SR/CR A1A PEDESTRIAN SAFETY & MOBILITY STUDY

PEDESTRIAN / BICYCLE SAFETY REVIEW

Focus Area A / Peninsula Avenue to E 3rd Avenue (New Smyrna Beach)

Pedestrian/Bicycle Safety Review Report for Focus Area A: SR A1A from Peninsula Avenue to E 3rd Avenue (New Smyrna Beach)

Issue #5: Push Button Placement**Figure 10****Figure 11****Description of Issue:**

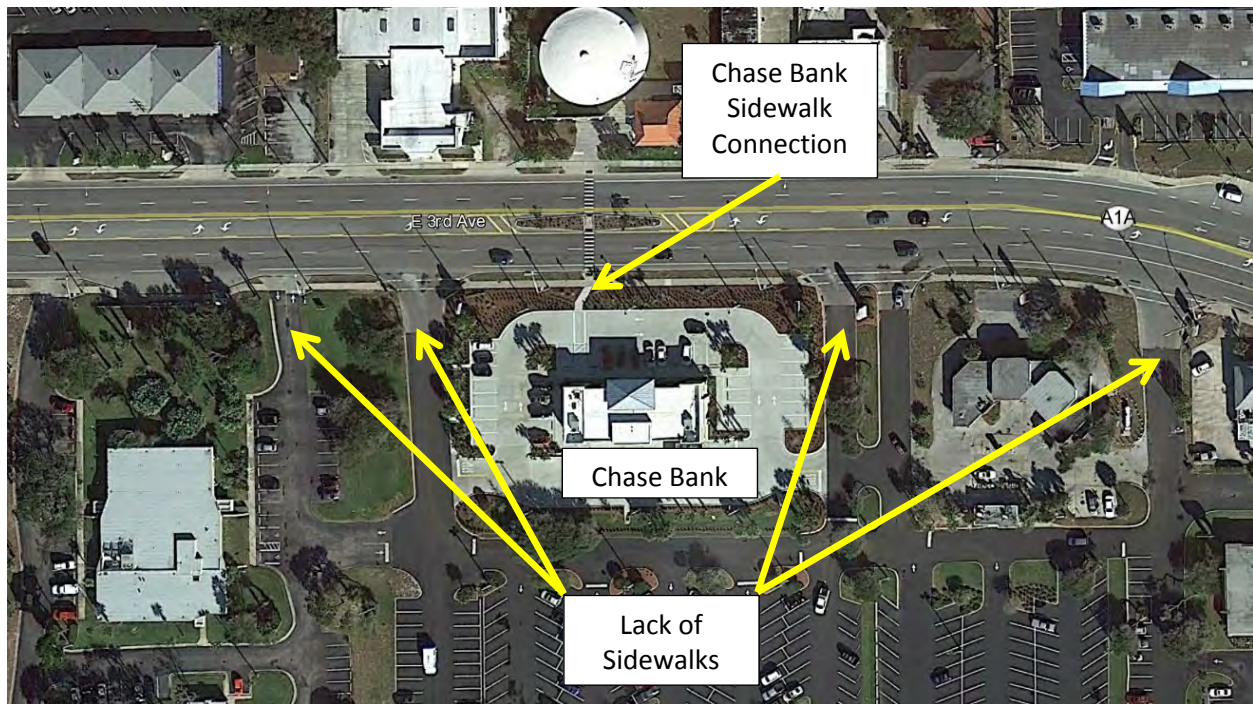
At the three signalized intersections throughout the corridor, the faces of the pedestrian push button detectors are perpendicular to the crosswalk, as displayed in **Figure 10**. Only the accessible pedestrian signal (APS) push buttons on the northeast (**Figure 11**) and southeast corners of the Horton Street/Saxon Drive intersection are properly oriented to be parallel to their corresponding crosswalk.

Consider rotating the pedestrian push button detectors at each of the signalized intersections so the face of the pedestrian detectors is parallel to the crosswalk to be used, as discussed in section 4E.08 of the *2009 Manual of Uniform Traffic Control Devices (MUTCD)*.

Figure 12**Description of Issue:**

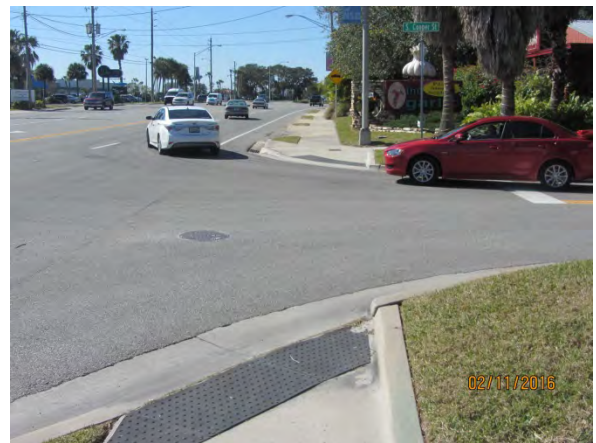
Sidewalks are provided along both sides of SR A1A for the entire limits of the study corridor, but there is limited sidewalk access to the commercial properties on the north and south sides of the roadway. The limited sidewalk connectivity creates situations where pedestrians must use the entrance/exit roadway for a hard surface to get to/from SR A1A leading to potential pedestrian/vehicle conflicts. Examples of some commercial properties that lack sidewalks are presented in **Figure 12**.

As properties redevelop along the corridor, consider requiring the property owner to construct sidewalks that connect to SR A1A. When the Chase Bank was constructed, the property provided a connection to the SR A1A south side sidewalk as displayed in **Figure 12**.

Figure 28

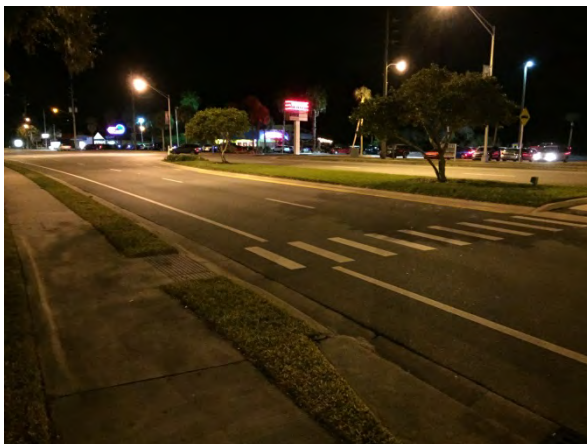
During nighttime conditions, a large oak tree was observed casting a shadow across the markings for the westbound travel lanes (**Figure 28**) and the north side of the crossing was dark relative to the south side of the crossing (**Figure 29**).

- Trim back the oak tree on the north side so the north side of the crosswalk is illuminated more than it is today. In the longer term consider installing pedestrian scale lighting on the north and south sides of the crosswalk.

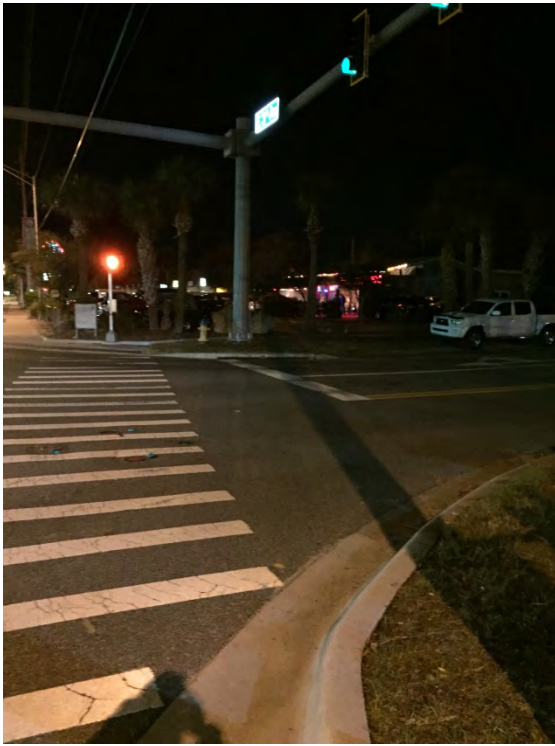
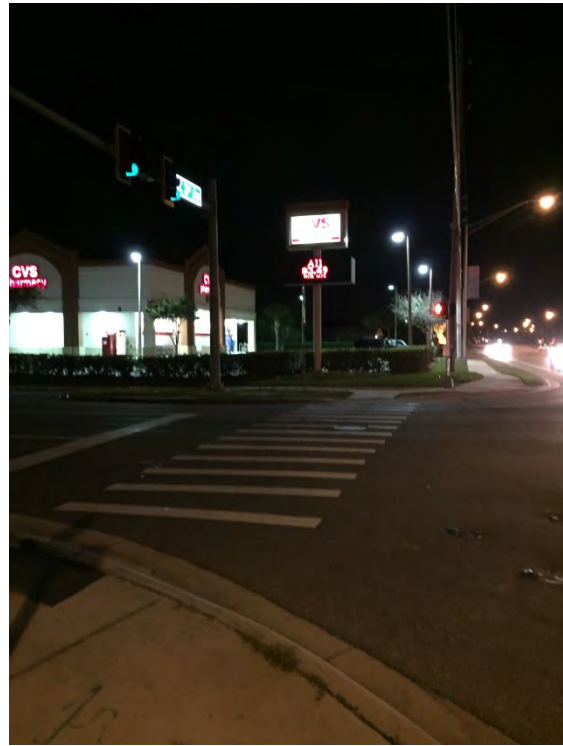
The study team observed a blank-out sign that reads “NO TURN ON RED” for the southbound approach at the intersection (**Figure 34** and **Figure 35**) but that was not working during the field review. The study team also observed a leading pedestrian interval for the west and east leg crosswalks at the intersection (preceding the northbound/southbound phase). Two crashes occurred between left turning vehicles and pedestrians in the west and east leg crosswalks.

The intersection also had APS installed for the east leg crosswalk (**Figure 36**).

Consider making the blank-out NO TURN ON RED sign facing the southbound approach active during the leading pedestrian interval. Also consider converting the blank-out sign to a sign that transitions between the NO RIGHT TURN ON RED message and a YIELD TO PEDESTRIANS message at the onset of the southbound green phase.

Because APS is already installed for the east leg, consider improving the other crosswalks at the intersection with APS to improve accessibility for visually-impaired users. Refer to MUTCD Section 4E.11 and Chapter 6 of NCHRP 3-62: Guidelines for Accessible Pedestrian Signals (http://www.apsguide.org/chapter6_geometry.cfm).

Figure 41

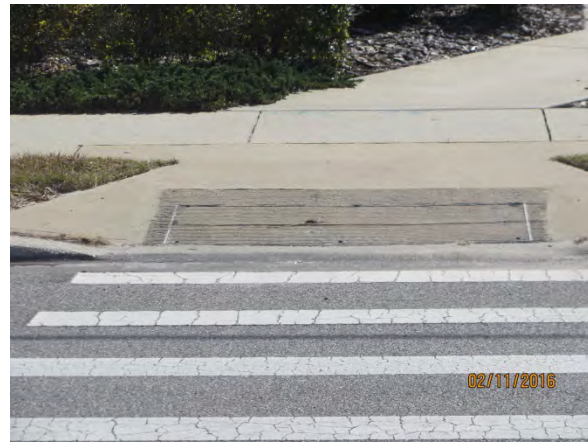
A mid-block crossing is located approximately 650' east of the SR A1A/Horton Street/Saxon Drive signalized intersection striped with old special emphasis crosswalk markings (**Figure 40**). The study team noted pedestrian warning signage at the crossing on the right side of the roadway in both directions and advanced pedestrian warning signage approximately 400' west and 425' east of the crossing. The south side of the crossing was missing a detectable warning surface as displayed in **Figure 41**.

- Install a detectable warning surface on the south side of the crossing per FDOT Design Standard Index 304.
